Millstone Power Station, Unit No. 2
Response to Request for Additional Information on RR-89-48 for the
Nozzle Inspection Ultrasonic Test Coverage Requirements in Order EA-03-009

Westinghouse Non-Proprietary Class 3
RAI Responses to Millstone Unit 2 Relaxation Request
WCAP-15813-NP, Revision 0

RAI Responses to Millstone Unit 2 Relaxation Request

Alloy 600 - Thermal Expansion and Stress-Strain

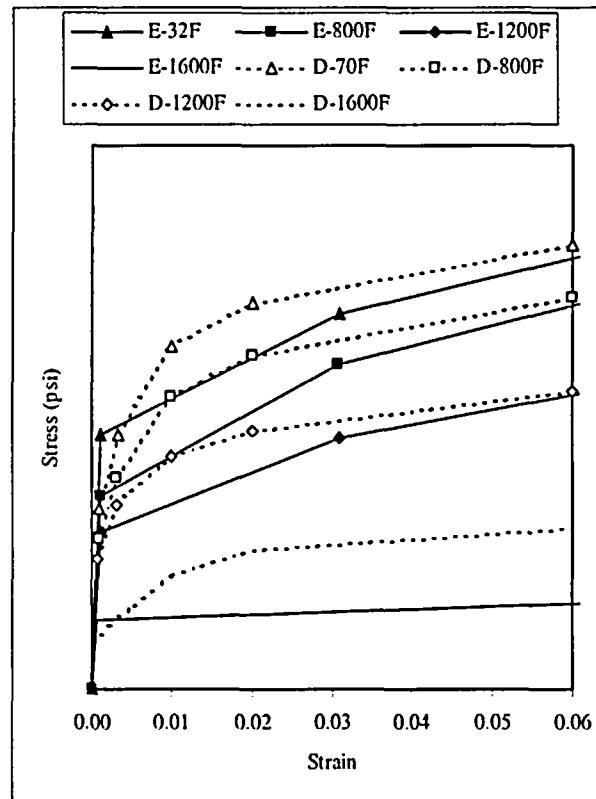
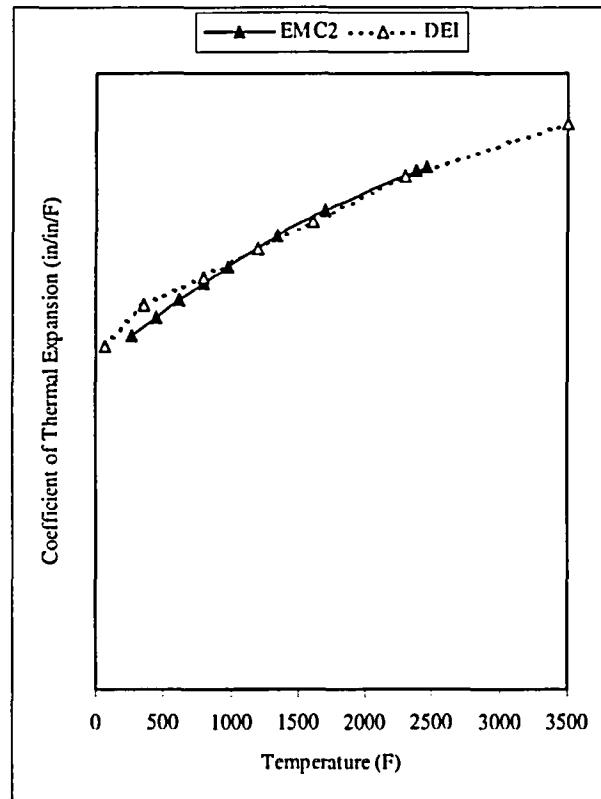
Provide the stress-strain curves for penetration tube, J-groove weld and vessel head used in your finite element method (FEM) stress analysis; justify the applicability of these stress-strain curves to your CRDM nozzle assembly. Test data should be provided to justify the use of either an elastic-perfectly plastic model or a strain hardening model for the Alloy 600 nozzle material in your FEM analysis.

Hoop Stresses at Weld

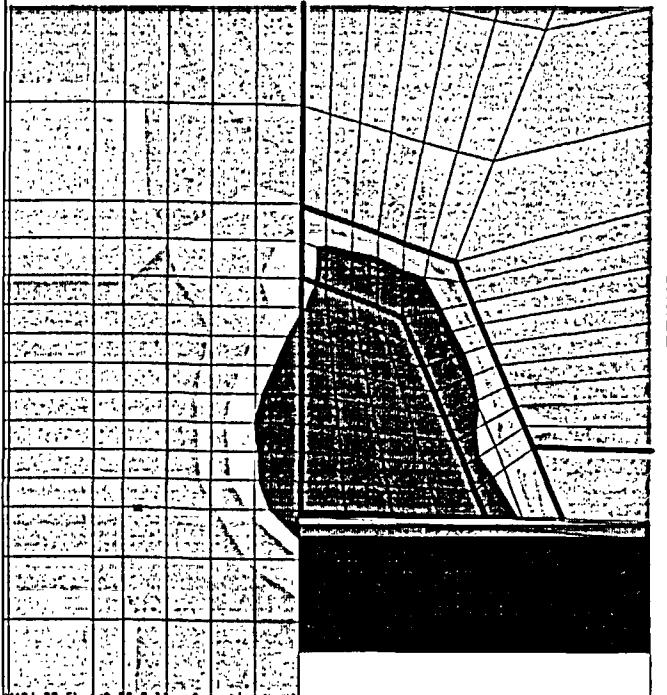
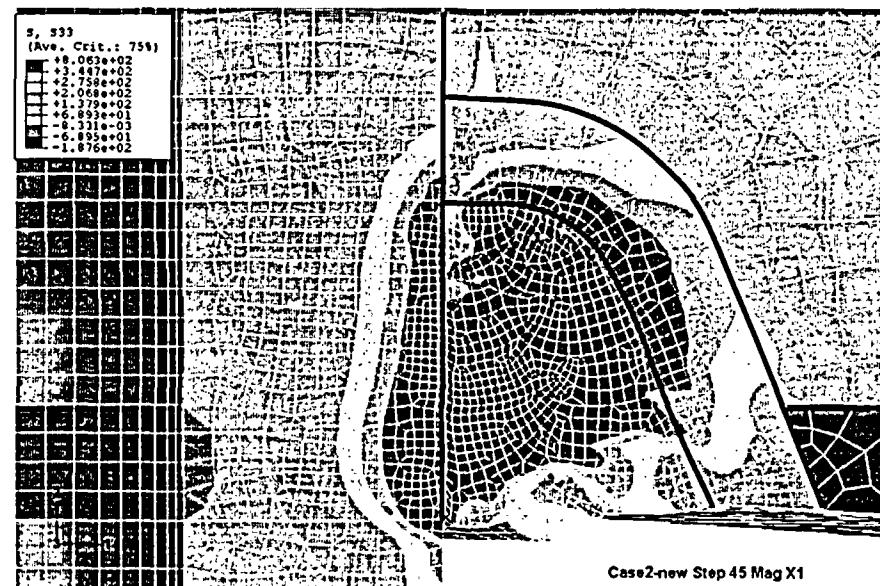
You mentioned in Section 5-3 that the vessel to penetration nozzle weld was simulated with two weld passes. Please provide the actual number of weld passes for fabricating the vessel to penetration nozzle weld and justify quantitatively that using two weld passes in your FEM modeling would adequately represent actual residual stresses.

The actual number of weld passes for fabricating the vessel to penetration nozzle weld is between 30 to 40 weld passes. The methodology of using two weld passes in the FEM modeling have been benchmarked with actual ovality measurements in Report EPRI TR-103696 dated July 1994. Recent study which compares the FEM results for a center penetration with two weld passes versus multiple weld passes indicated that the results

are in good agreement. This information was provided in a presentation by Dominion Engineering to the NRC staff in September 2002. The presentation is attached.
